Product Recall

Subject: RECALL 07V-544– Printed Circuit boards, Circuit Protection, & Power Cable

Instruction Sheet #TBB 85490091
RECALL #07V-544

SUBJECT: PRINTED CIRCUIT BOARDS, CIRCUIT PROTECTION, & POWER CABLE REPLACEMENT

Figure 1

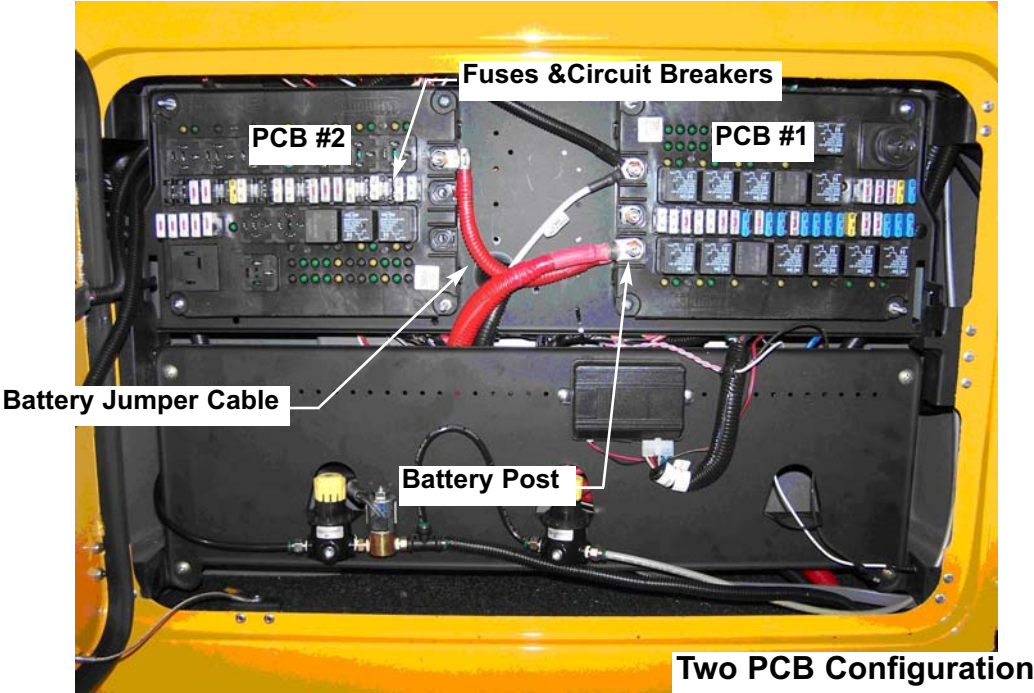
Figure 1 shows the two PCB configuration and **Figure 2** shows the three PCB configuration. These figures are typical configurations and will be used as a reference for parts identification.

1. Label the cables and wires attached to each PCB battery post stud and remove the locknut.
2. Remove the PCB Jumper Cable, and discard, see **Figures 1 and 2**.
3. With all the wiring removed from the battery post, place the new Cable, #TBB 85520241 for the two PCB configuration or #TBB 85520242 for the three PCB configuration, as the first cable installed and in the orientation shown in **Figures 3 and 4**. If there are additional wires installed on this battery post stud, be sure to slightly stagger the terminals so they are setting flat on each other, and will not side load the battery post stud when the locknut is tightened. There should not be more than three separate terminals attached to the battery post stud.
4. Once the wires are oriented on the battery post stud from step 3, install the flat washer and locknut. Torque the locknut to 65 in-lbs.
